**Regulation 19 Addendum: Proposed Modifications to the South Derbyshire
Local Plan Part 1 Review 2022-2041**

Regulation 19 Addendum
REPRESENTATION FORM

Summary: PM21 turns what was a conditional requirement for an A516–A38 link road into a fixed, mandatory one and ties it to the wider South Derby Integrated Transport Link (SDITL). It is a new strategic infrastructure requirement. I object on three main principles:

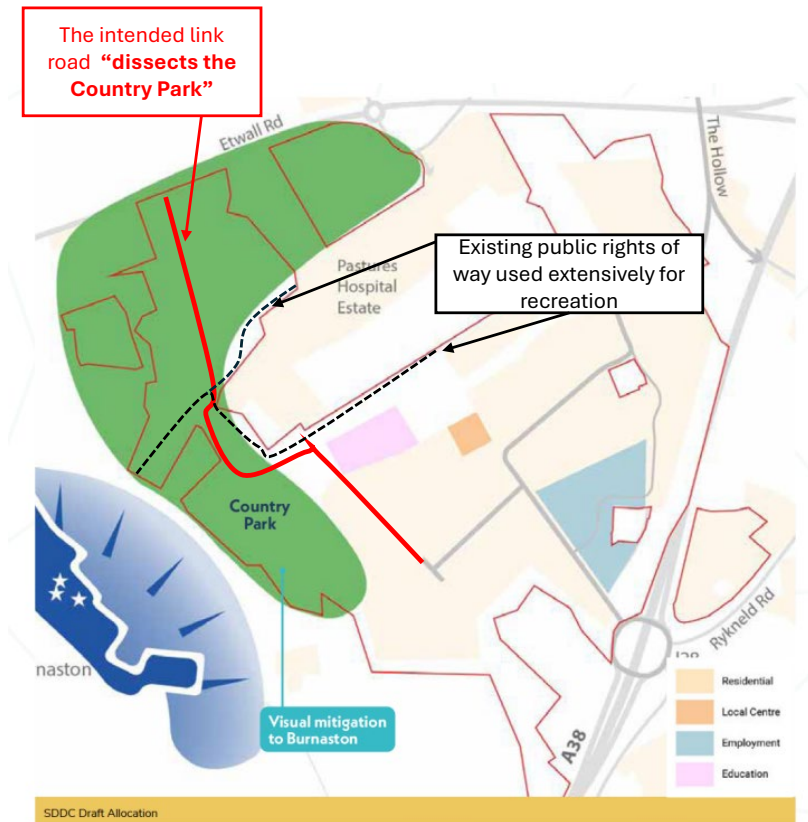
AM73's own admission that the road "dissects the Country Park" contradicts any suggestion this is a minor downstream detail: the plan cannot simultaneously fix a road that dissects a Country Park and say its sustainability performance is unchanged and no alternatives arise.

The Council's own SA Report for the Proposed Modifications says, in plain terms, that "*no reasonable alternatives... have been identified*" for the amended policies. I cannot make an intelligent response on alternatives the Council's own SA records as not having been identified.

Proposed indicative layout (PM22): link road shown crossing the Country Park and existing public rights of way (annotations mine).

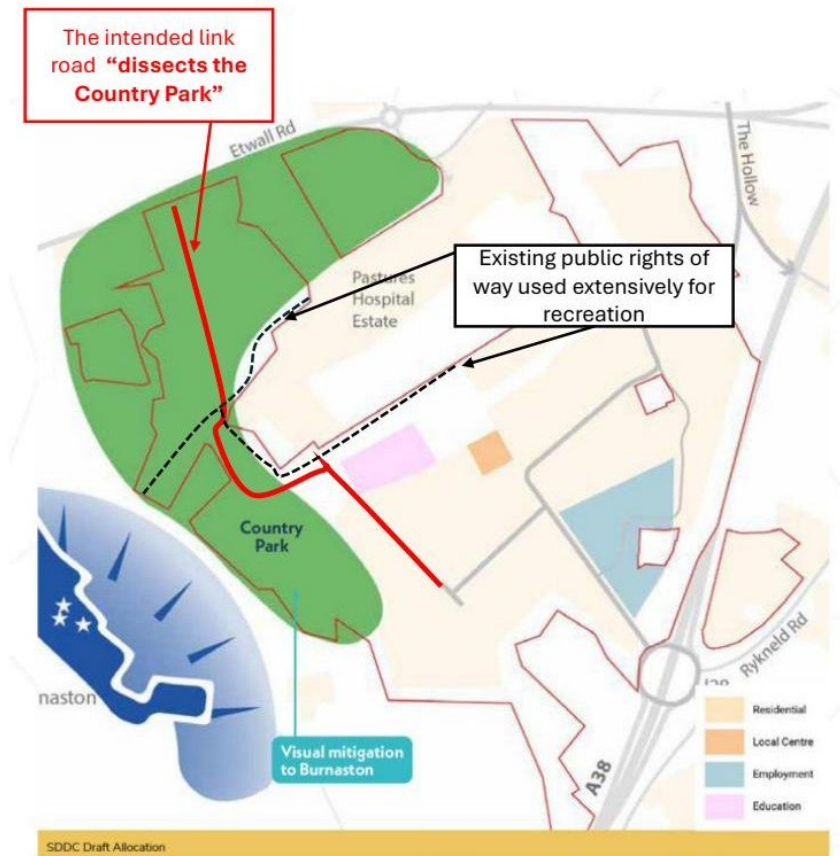
The SA identifies the receptors that matter on this land: the open gap with Burnaston, the Country Park’s role in stopping settlements coalescing, and the setting of the Pastures Hospital Listed Buildings. The new layout routes the road through precisely that land. It also crosses the existing public rights of way that are used extensively for recreation. I have noted over 150 people walking these fields daily, and the corridors are actively used by wildlife (evidence can be provided on request). The annotated extract below shows the position:

The Council's own modifications confirm the point rather than answer it. AM73 concedes the road "dissects the Country Park," and its justification text plans "higher densities... adjacent to the main urban parts of the link road" - the layout and supporting text treat the road as settled and build the development form around it. Yet the SA maintains that the sustainability performance of the plan is unchanged and that no alternatives arise. A layout cannot both dissect the Country Park and leave the plan's sustainability performance unchanged.

The revised layout introduces a parcel of housing fronting the A516 in the north of the site, physically separated from the rest of the development by the Country Park. This is a new spatial choice, and it is unsupported by any evidence.

It is the Council's own description of the change. AM73 states that "the bulk of the development will be to the south of the site with some more limited development fronting onto the A516," and that higher densities are expected "adjacent to the main urban parts of the link road." The northern housing is therefore placed not where the services are, but where the road is.

Option A — a full and lawful response. Delete PM22 as drafted (the layout reflecting PM16, PM21 and housing fronting the A516), and the Council to carry out the steps set out in my PM21 representation:

Only once an access and movement option has been properly assessed and selected should a revised indicative layout be published to reflect it. The layout should follow the assessment, not the other way round.

Option B — delete PM22 / revert to the previously consulted layout. A layout whose only stated reason is to “reflect” PM16 and PM21 has no basis if those modifications are deleted.
